SUPPLEMENTAL REPORT TO THE HEARING OFFICER

PROJECT NUMBER: 2019-000010

PROJECT LOCATION: 24937 Mulholland Highway, Calabasas

Re: Response Letter to Cold Creek Community Council (CCCC) to LA County Regional Planning Department
Project No. 2019-000010-(3)

- A. Revised Project Plans (Lots 3 and 4)
- B. Nearby Study Area Map of existing residential building SF

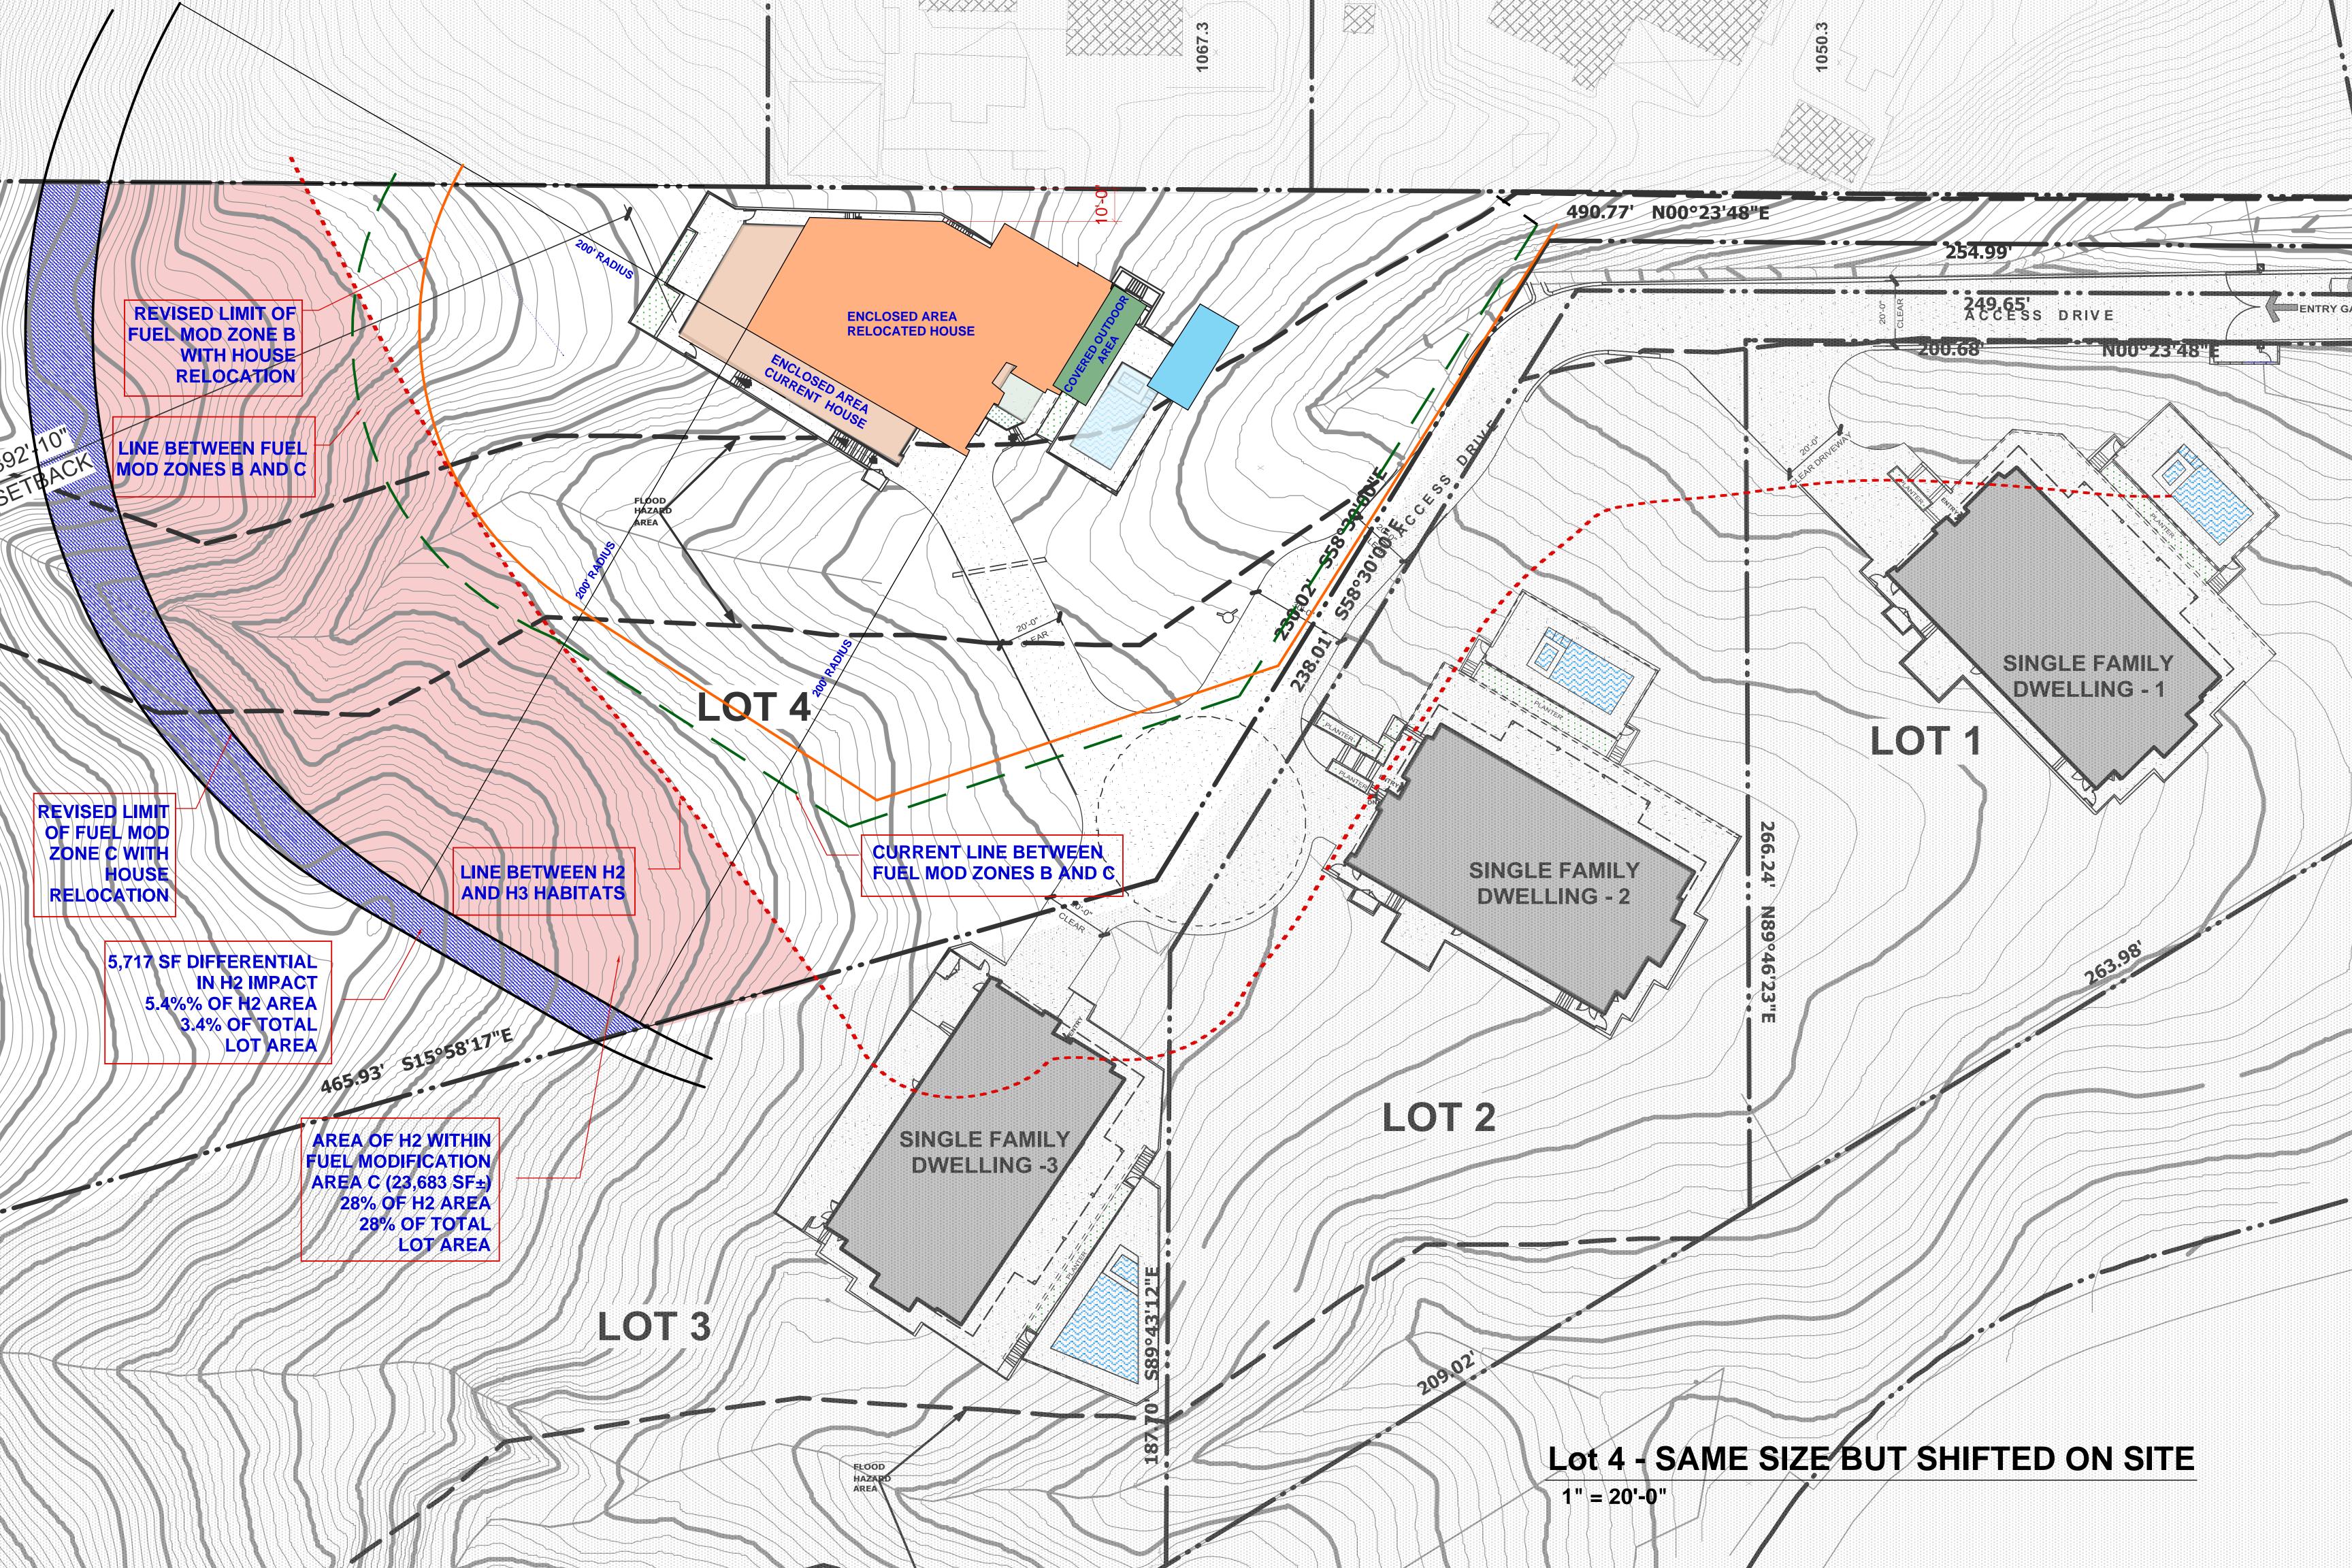
Lot 3 (APN: 4455-019-046): The residence is proposed to be reduced in size by 20% in building footprint at the rear of the building pad, reducing the total size of the residence from 4,114 square feet ("Original Lot 3 Design") to 3,291 square feet ("New Lot 3 Design"). The reduction in footprint greatly impacts the amount of H2 habitat that is preserved and to fuel modification zones B and C. The lot size is 442,134 sf (10.15 acres) and the existing H2 area on Lot 3 is 430,695 sf (9.89 acres).

Lot 4 (APN: 4455-019-047): The residence is proposed to be relocated and shifted southward from its originally proposed location while maintaining the same size and therefore reducing impacts to fuel modification zones B and C and reducing the amount of disturbance in the H2 habitat area (5,717 sf differential) from 35 % to 29.5%. The relocation of the residence also minimized impacts to the existing floodplain/hazard area to the west and location and distance to the lot 3 residence. The lot size is 166,934 sf (3.83 acres) and the existing H2 area on Lot 4 is 104,729 sf (2.4 acres).

Original Lot 3 Design	New Lot 3 Design
House Size	4,114 sf	3,291 sf
H2 Habitat Total Affected (sf)	64,096 sf	59,832 sf (4,264 sf
		reduction)
% of H2 Area Impacted	14.5%	13.89%

Original Lot 4 Design	New Lot 4 Design
House Size	4,186 sf	4,186 sf
H2 Habitat Total Affected (sf)	36,663 sf	30,946 sf (5,717 sf
		reduction)
% of H2 Area Impacted	35%	29.5%
